SUBJECT: CATAWBA NUCLEAR STATION, UNITS 1 AND 2 - STAFF ASSESSMENT OF INFORMATION PROVIDED PURSUANT TO TITLE 10 OF THE *CODE OF FEDERAL REGULATIONS* PART 50, SECTION 50.54(f), SEISMIC HAZARD REEVALUATIONS RELATING TO RECOMMENDATION 2.1 OF THE NEAR-TERM TASK FORCE REVIEW OF INSIGHTS FROM THE FUKUSHIMA DAI-ICHI ACCIDENT (TAC NOS. MF3965 AND MF3966)

STAFF ASSESSMENT BY THE OFFICE OF NUCLEAR REACTOR REGULATION

RELATED TO SEISMIC HAZARD AND SCREENING REPORT

CATAWBA NUCLEAR STATION, UNIT S. 1 AND 2

Figure 3.3-1 Plot of Staff's and Licensee's Base Case Shear-Wave Velocity Profiles for the Catawba site

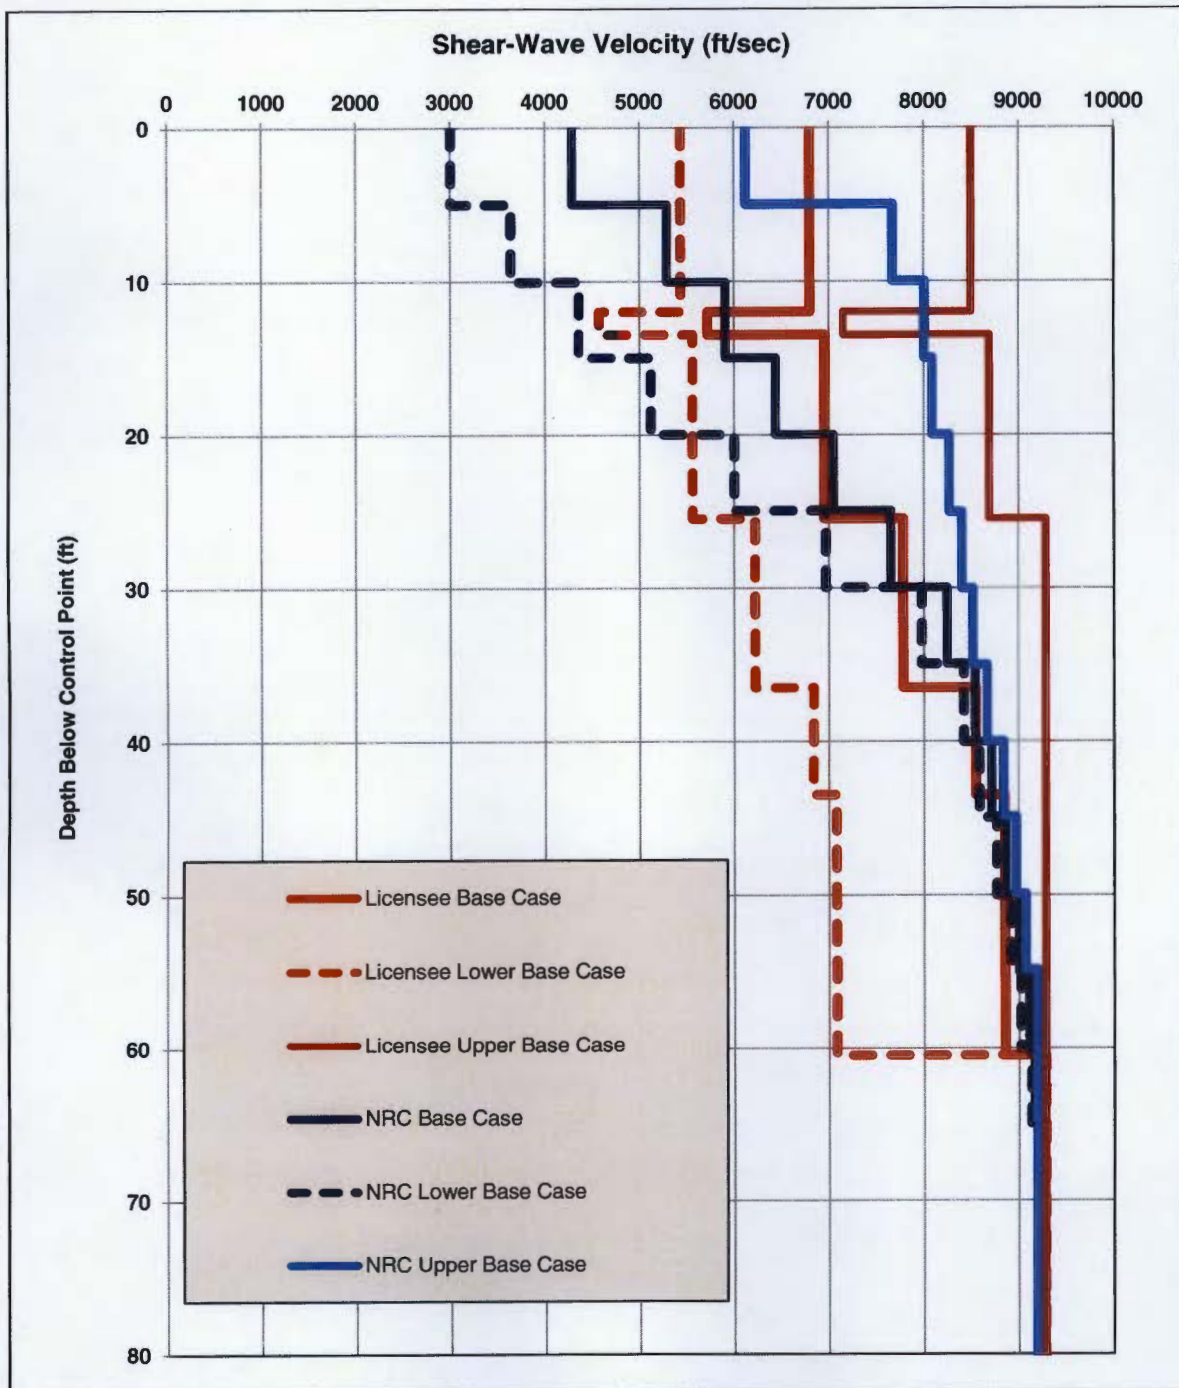
base case profiles were developed by the licensee using a natural log deviation of 0.2. Figure 3.3-1 of this assessment shows the licensee's three shear-wave velocity base case profiles. As the SPID recommends that a site's control point elevation should be at the top of competent rock, the staff asked the licensee to justify including the fill concrete in its site response profile. In a letter dated January 8, 2015, 2015 (Henderson, 2015), the licensee responded to the staff's request for additional information by stating that the concrete fill was considered an extension of the underlying rock and was used to restore the foundation elevation. The licensee further stated that in at a few locations across the site the top of continuous rock is below the design bottom of the substructure mat of significant structures such as the Reactor Building. As such, at these locations, fill concrete was placed to extend the top of continuous rock up to the foundation grade level. As described below, the staff evaluated the licensee's inclusion of about 12 ft [3.7 m] of concrete fill in its site profile by performing a confirmatory site response analysis. The staff's results show that the licensee's inclusion of the fill concrete had a negligible impact on the resulting hazard curves and GMRS.

To capture the uncertainty in the site subsurface geology, the staff developed three base case shear-wave velocity profiles. The upper and lower base case shear-wave velocity profiles are based on the downhole measurements obtained from Borings A-61 and A-63, which are presented in Figures 2-98 and 2-99, respectively, of the Catawba, Units 1 and 2 UFSAR (Duke Energy Carolinas, 2012). The middle or best estimate base case profile represents the geometric mean of the shear wave velocities for the upper and lower base case profiles. The staff's base case profiles are similar to the licensee's profiles above the depth of 25 ft [7.6 m]. Below this depth the shear wave velocities for the licensee's lower base case profile are lower than the staff's velocities for its lower base case profile. In addition to the differences in the lower base case profile, the licensee's and staff's profiles also differ for the upper layer because the staff did not include the 12 ft [3.7 m] of fill concrete in its site response profile. As described below, these differences between the staff's and licensee's profiles did not have a significant impact on the final hazard curves or GMRS for the site. Figure 3.3-1 of this assessment shows the staff velocity profile compared to the base case profiles developed by the licensee.

Figure 3.3- 2 Plot Comparing the Staff's and the License's Median Amplification Functions and Uncertainties for two input loading levels for the Catawba site

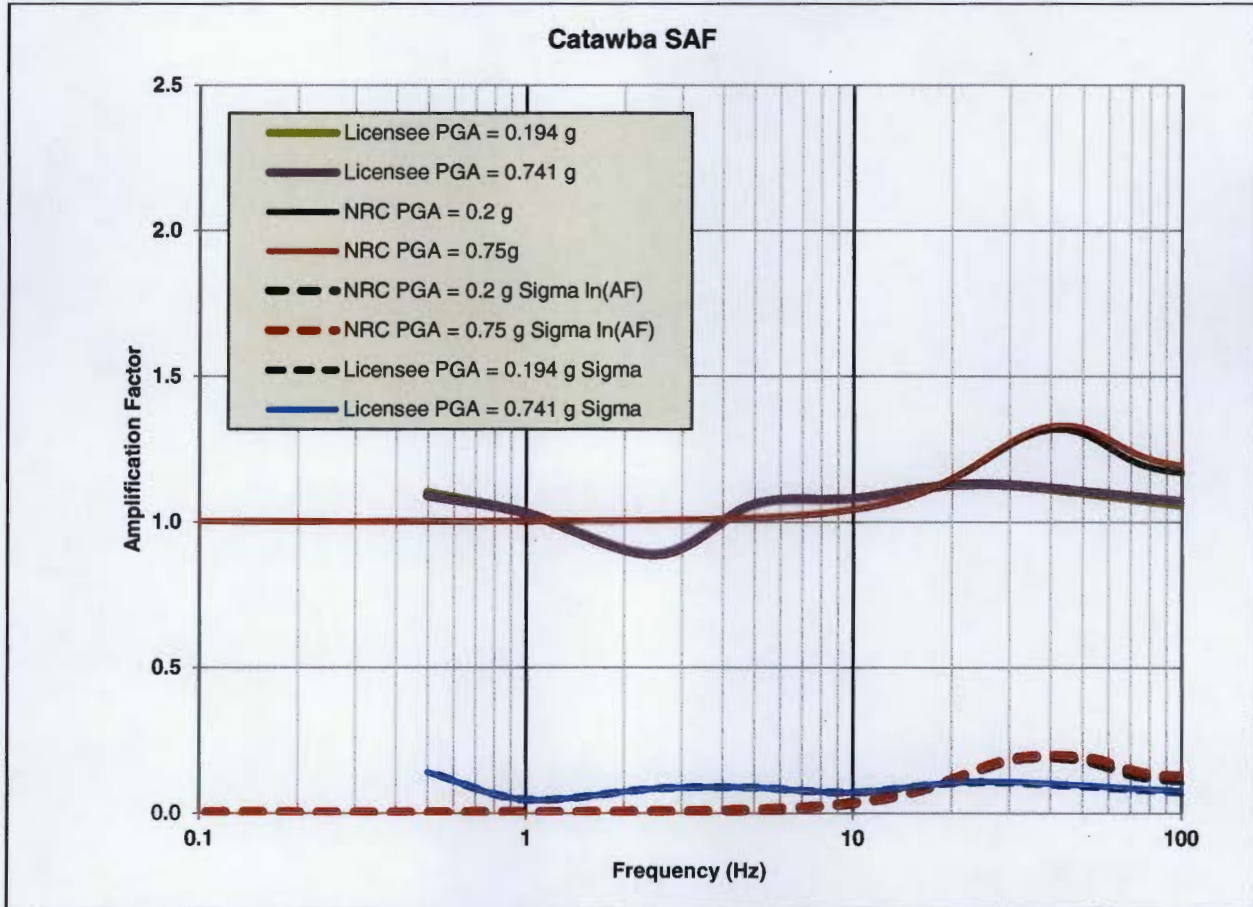
Figure 3.3-2 of this assessment shows a comparison of the staff's and licensee's median site amplification functions and uncertainties (± 1 standard deviation) for two of the eleven input loading levels. Due to the use of low damping values and modeling of the rock behavior as linear, the staff's confirmatory amplification factors are essentially one for the frequency range below approximately 10 Hz. Amplification functions calculated by the licensee are also fairly close to

one, varying between 0.8 to 1.3 for frequencies above 20 Hz. In addition, the staff's calculated amplification factor uncertainties are very similar to those of the licensee's.

Figure 3.3-3 Plot Comparing the Staff's and the Licensee's Mean Control Point Hazard Curves at a Variety of Frequencies for the Catawba site

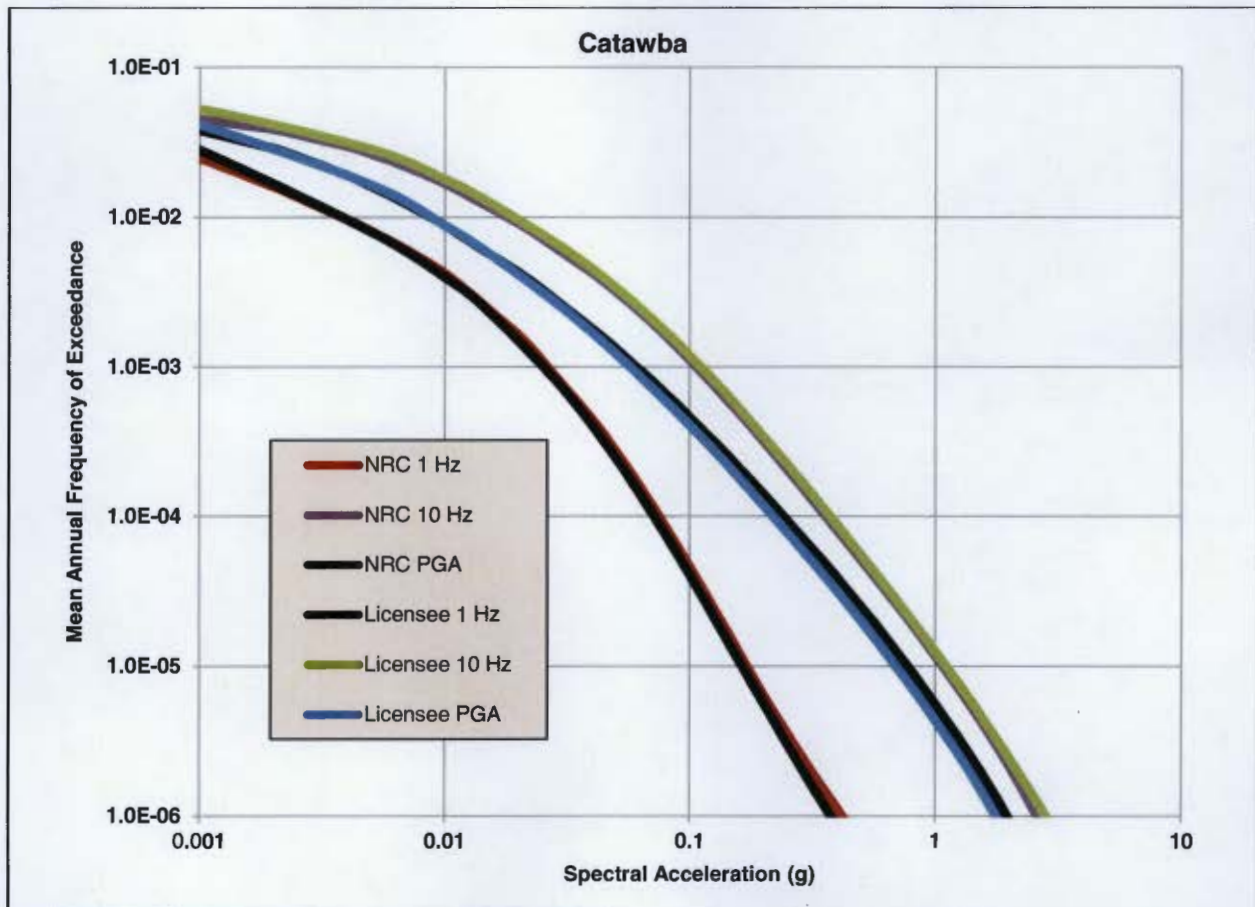
Overall, the licensee's approach to modeling the subsurface rock properties and their uncertainty results in amplification factors that vary more than those developed by the staff. However, as shown in Figure 3.3-3 of this assessment, these small differences in the site response analysis do not have a large impact on the control point seismic hazard curves or the resulting GMRS, as discussed below. Appendix B of the SPID provides guidance for performing site response analyses, including capturing the uncertainty for sites with less subsurface data; however, the guidance is neither entirely prescriptive nor comprehensive. As such, alternative approaches in performing site response analyses, including the modeling of uncertainty, are acceptable for this application.

Figure 3.4-1 Comparison of the Staff's GMRS with Licensee's GMRS and the SSE for the Catawba site

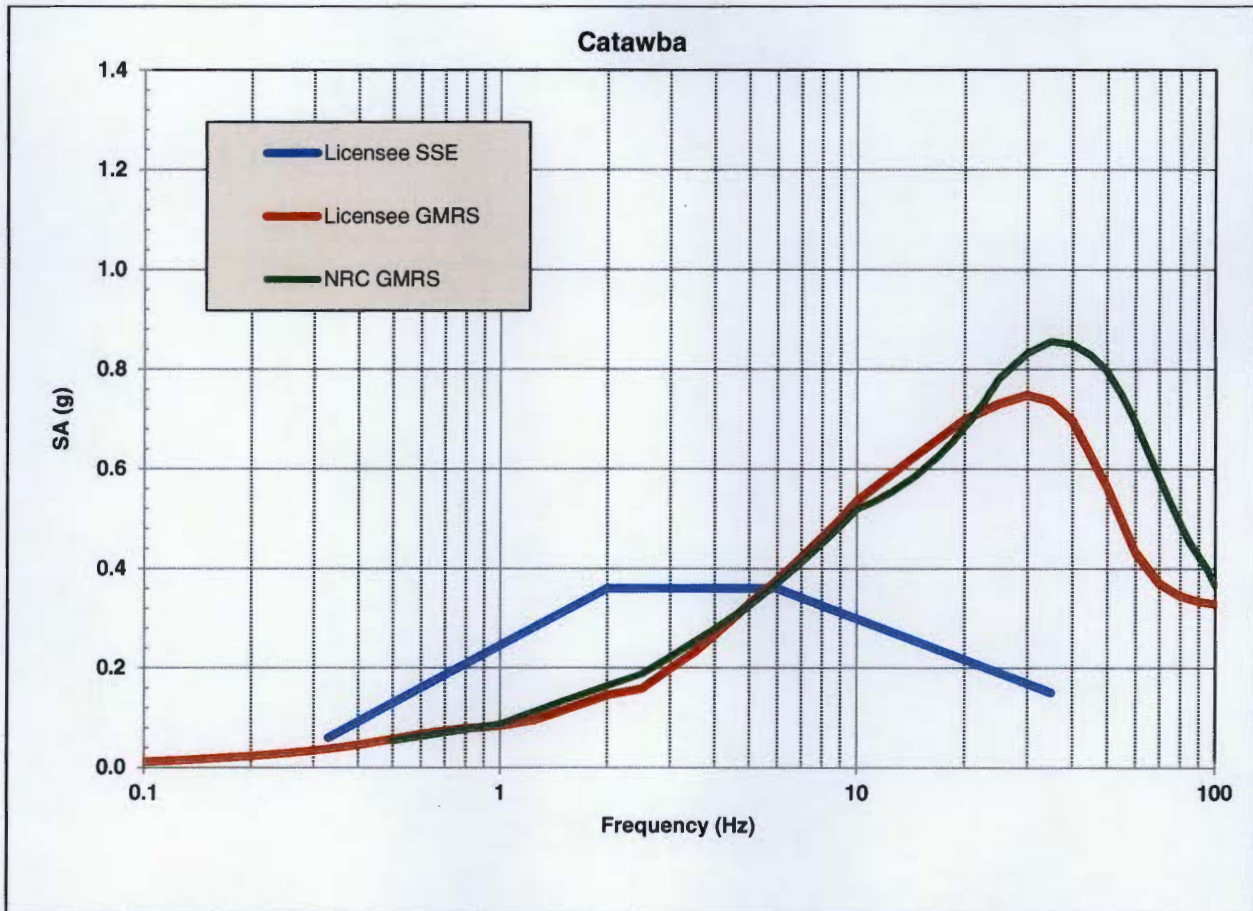
The staff independently calculated the 10^{-4} and 10^{-5} UHRs using the results of its confirmatory PSHA and site response analyses, as described in Sections 3.2 and 3.3 of this staff assessment, respectively. Figure 3.4-1 of this assessment shows a comparison of the GMRS determined by the licensee to that determined by the staff.

As shown in Figure 3.4-1, the licensee's GMRS is similar to the staff's confirmatory GMRS. However, NRC staff's confirmatory GMRS is higher than the licensee's at frequencies above 20 Hz. As described above in Section 3.3, the staff concludes that these differences over the higher frequency range are primarily due to the differences in the site response analyses performed by the licensee and staff. The staff concludes that these differences are acceptable for the response to the 50.54(f) letter because the licensee followed the guidance provided in the SPID with respect to both the PSHA and site response analysis for the Catawba site.

The staff confirms that the licensee used the present-day guidance and methodology outlined in RG 1.208 and the SPID to calculate the horizontal GMRS, as requested in the 50.54(f) letter. As such, the staff concludes that the GMRS determined by the licensee adequately characterizes the reevaluated hazard for the Catawba site. Therefore, this GMRS is suitable for use in subsequent evaluations and confirmations, as needed, for the response to the 50.54(f) letter. The staff performed both a PSHA and site response confirmatory analysis and achieved results consistent with the licensee's horizontal GMRS.
